**WHITE LAKE TOWNSHIP
ZONING BOARD OF APPEALS**

**REPORT OF THE
COMMUNITY DEVELOPMENT DEPARTMENT**

Applicant: Ginko Investment, LLC (John Sutphin)

RE: Ginko Self-Storage
Preliminary Site Plan and Special Land Use – Review #4

ORIGINAL ISSUE DATE:
 FEBRUARY 2, 2023
 DRAWING TITLE
PRELIMINARY SITE PLAN

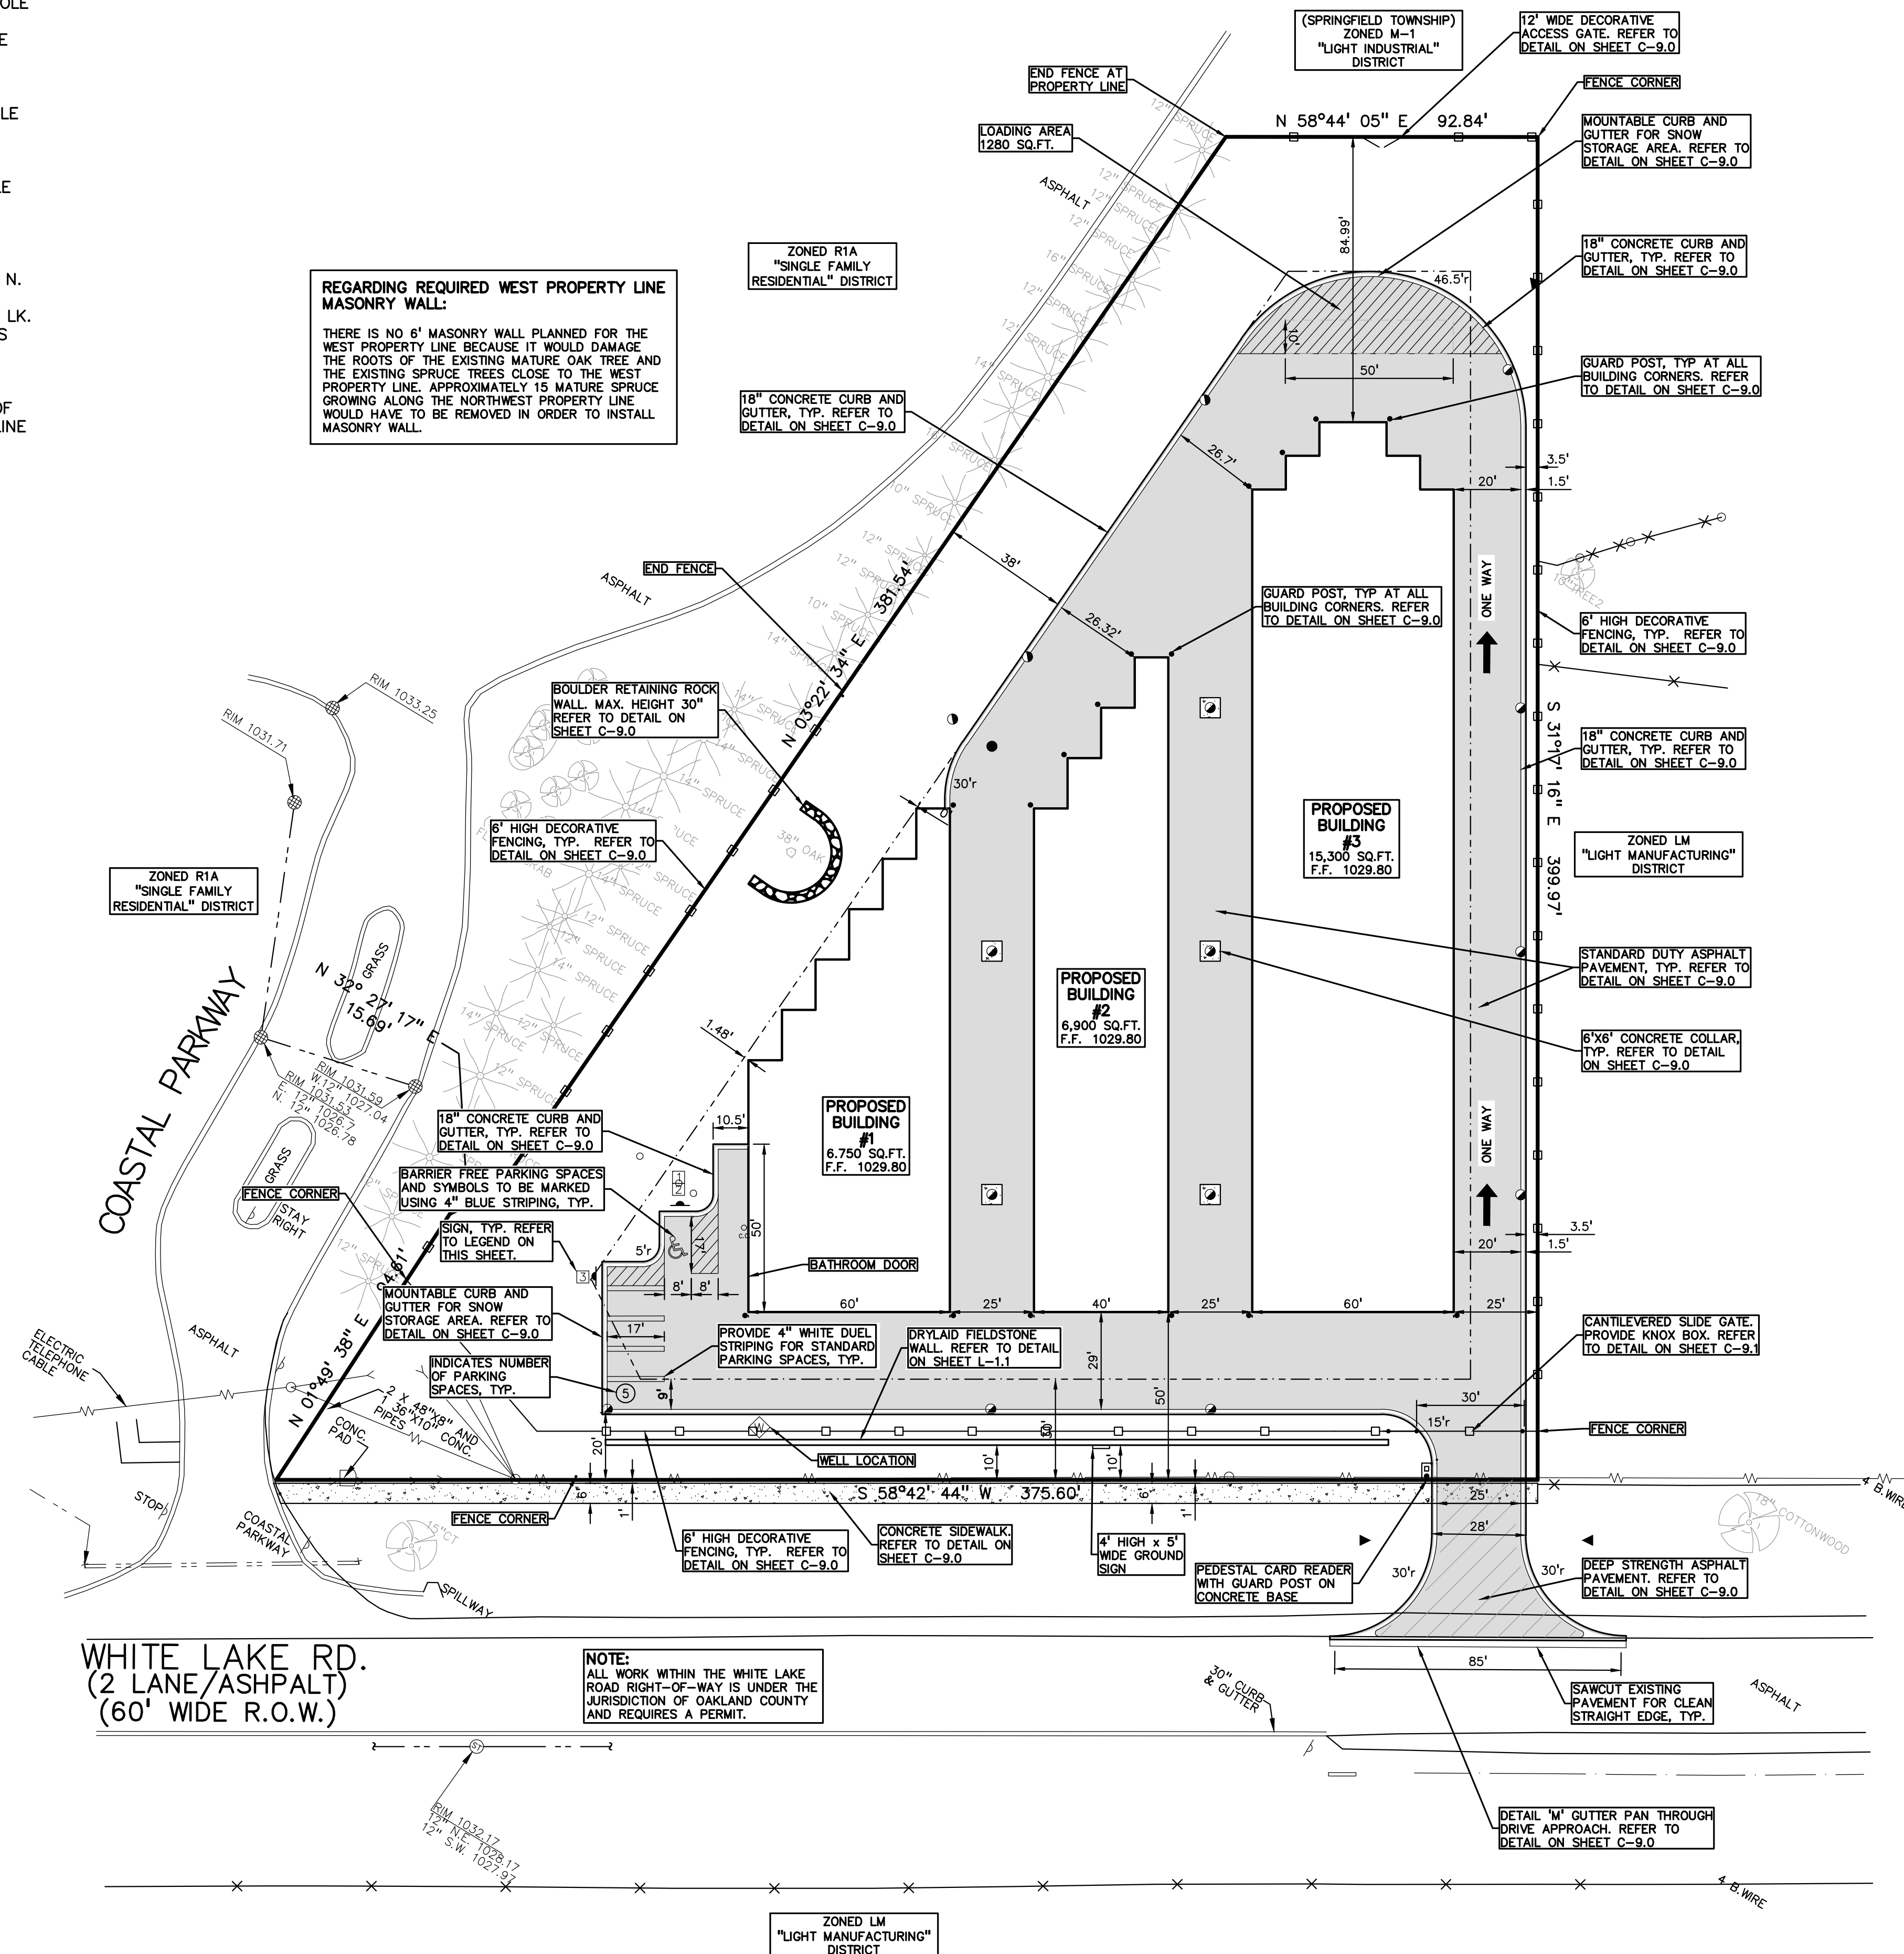
A 28-foot-wide (now 30-foot-wide) cantilevered slide gate is proposed at the driveway (Sheet C-3.1 still shows a 28-foot-wide gate – revise for consistency). (Comment addressed. Sheet C-3.0 shows the gate is 30-foot-wide; the 28-foot dimension noted on Sheet C-3.1 is the dimension of the access drive from back-of-curb to back-of-curb (25-foot-wide drive aisle provided between edges of the gutter pan). Gated vehicular access is subject to review and approval by the Fire Department, and a permit is required from the Building Official. (Comment remains as a notation. Gate details/specifications shall be provided at final site plan).

Sheet C-3.1 shall be revised to demonstrate how a fire truck will access Building 1 (via the drive aisle east of Building 1 and west of Building 2?). Can a 40-foot-long truck driving south via the aforementioned access aisle make an east/west turn? (Comments outstanding). (Comments addressed. Sheet C-3.1 has been revised to show the requested turning movements). Pursuant to the zoning ordinance, designation of fire lanes is required at preliminary site plan.

The proposed west side yard setback (drive aisle/maneuvering lane) is 25 feet. If a 38-foot greenbelt is not provided, a variance is required from the Zoning Board of Appeals. (Comment addressed. A 38-foot setback from the west property line has been proposed).

PRELIMINARY LANDSCAPE PLAN

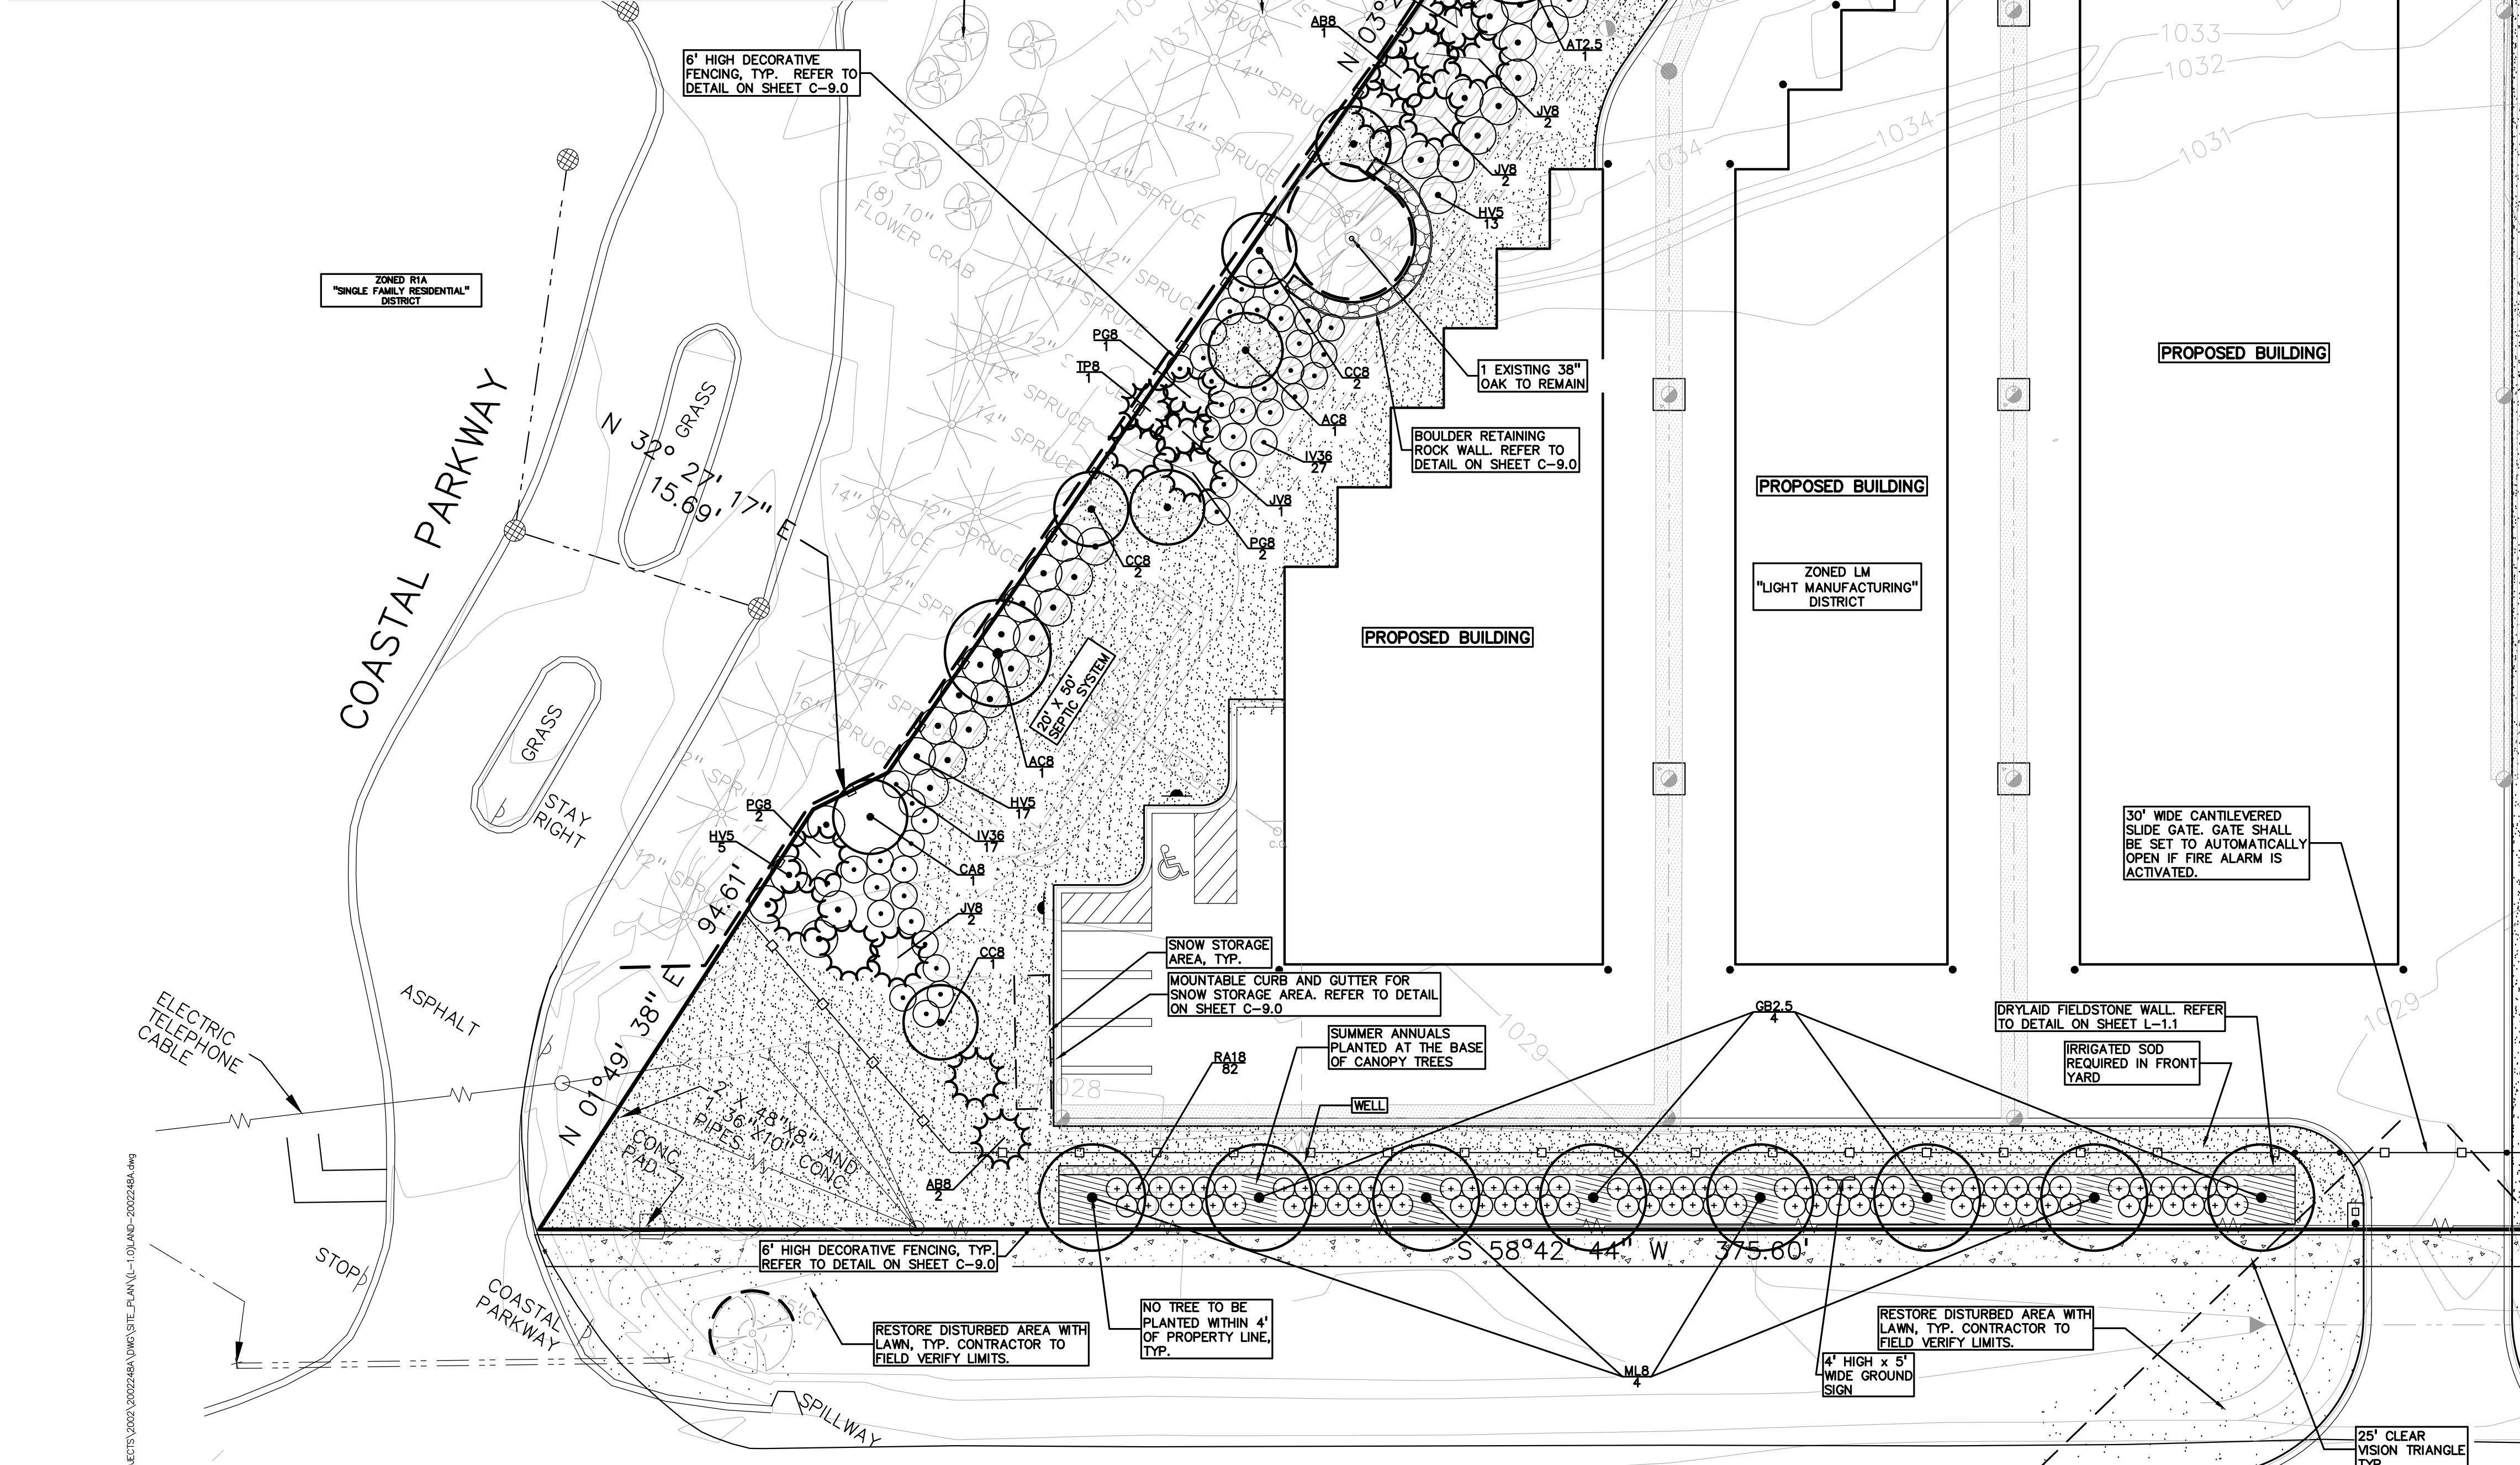
- **An extensive land form buffer (six-foot berm landscaped in accordance with the ordinance), or, a land form buffer (three-foot berm landscaped in accordance with the ordinance) AND a six-foot masonry screen wall (landscaped in accordance with the ordinance) are required along the west property line. If not provided, a variance is required from the Zoning Board of Appeals. (Comment outstanding. A variance is required from the Zoning Board of Appeals). (The Applicant's engineer stated a variance will be requested).**

- **No more than two planted trees in a row shall be of the same species.** (Comment outstanding. Three Eastern Red Cedar trees are planted in a row along the west property line). (Comment outstanding. Three white spruces in a row are now proposed along the west property line). (Comment addressed. The landscape plan has been revised accordingly).

- **Lawn in the front yard shall be sod and lawn elsewhere shall be hydroseed or sod.** (Comment addressed. It appears irrigated sod lawn has been proposed around the entire site except in the landscaped area along the west property line. In the Key on Sheet L-1.0 there is a symbol for restored lawn, though staff did not locate any such areas on the plan. If not proposed, this item shall be removed from the Key). (The Key has been modified to indicate restored seed lawn at areas disturbed in the right-of-way or adjacent properties).

REGARDING REQUIRED WEST PROPERTY LINE MASONRY WALL:
THERE IS NO 6" MASONRY WALL PLANNED FOR THE WEST PROPERTY LINE BECAUSE IT WOULD DAMAGE THE ROOTS OF THE EXISTING MATURE OAK TREE AND THE EXISTING SPRUCE TREES CLOSE TO THE WEST PROPERTY LINE. APPROXIMATELY 15 MATURE SPRUCE GROWING ALONG THE NORTHWEST PROPERTY LINE WOULD HAVE TO BE REMOVED IN ORDER TO INSTALL MASONRY WALL.
